2024-73 Tower Painting Project Addendum #1 – June 4, 2024

We received the following questions regarding this RFQ:

SUBJECT: TOWER MAINTENANCE INSPECTION
Frankfort, IL
200' Rohn SSVMW Self Supporting Tower

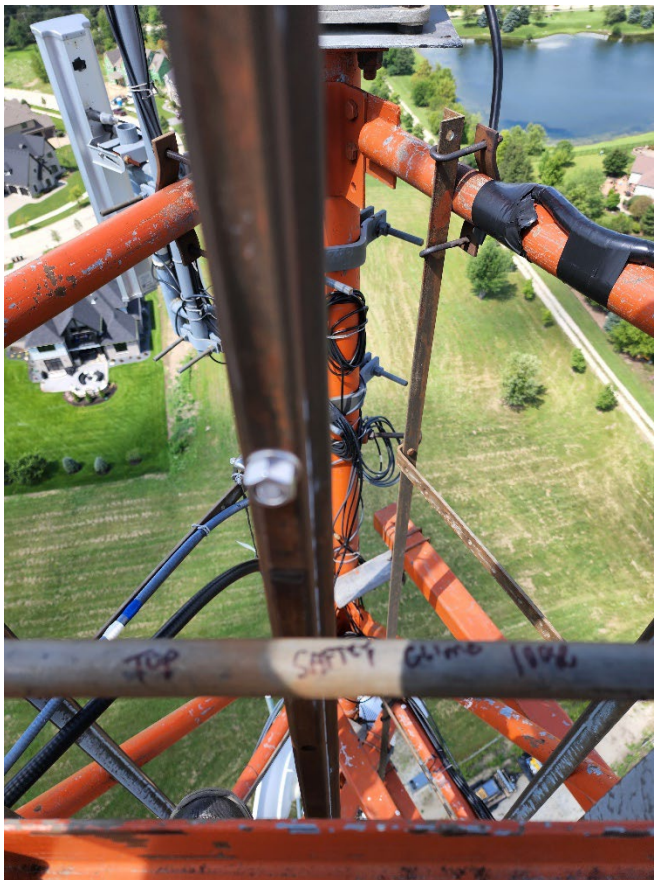
issue 1, top safety climb support missing, this is a non-standard anti climb, and we suggest replacing with a newer model

issue 2 – paint condition poor

Paint condition poor

Paint condition is poor, galvanized rust bleed & hardware rust is plentiful

Issue 3 – base grounds needs to be cadweled

Issue 4 Grout needs repair

Issue 5 Anchor bolt inspection, water could be getting trapped

Issue 6 – wi fi clamps should be Valmont Pucks or cross over clamps

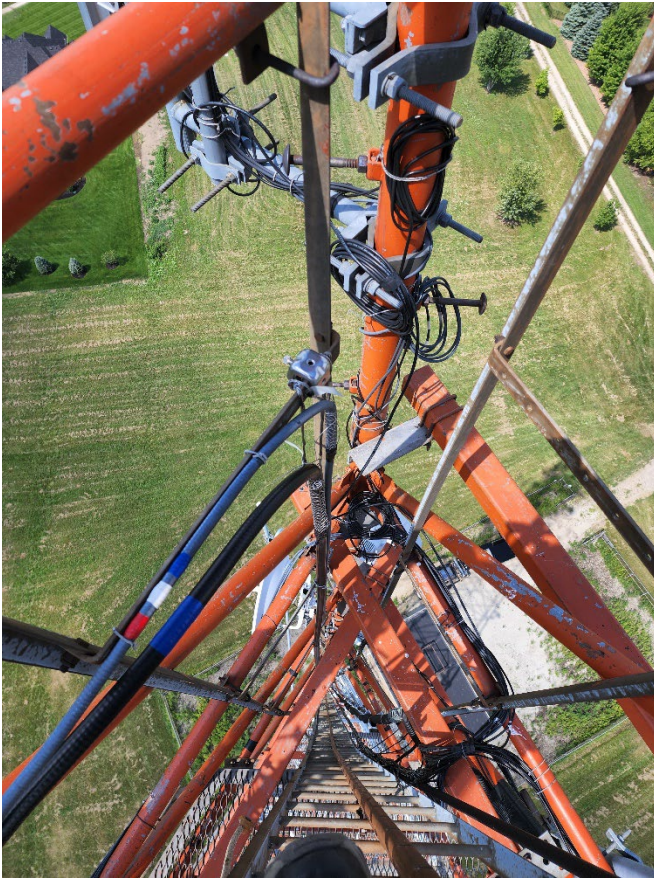
Issue 6 wi fi clamps should be replaced

Issue 7 – wi fi quality, poorly supported wires, many unused

Issue 8 – hawks Nest @ 90', monitor as needed

Issue 8 Hawks nest @ 90' Climbing leg

Issue 9 Weed Control needed, not just periodic spraying but a full soil neutralization program with quarterly sprays

Issue 9 Weed Control

Issue 10 – removal of old equipment (mounts, tie backs, cables etc.)
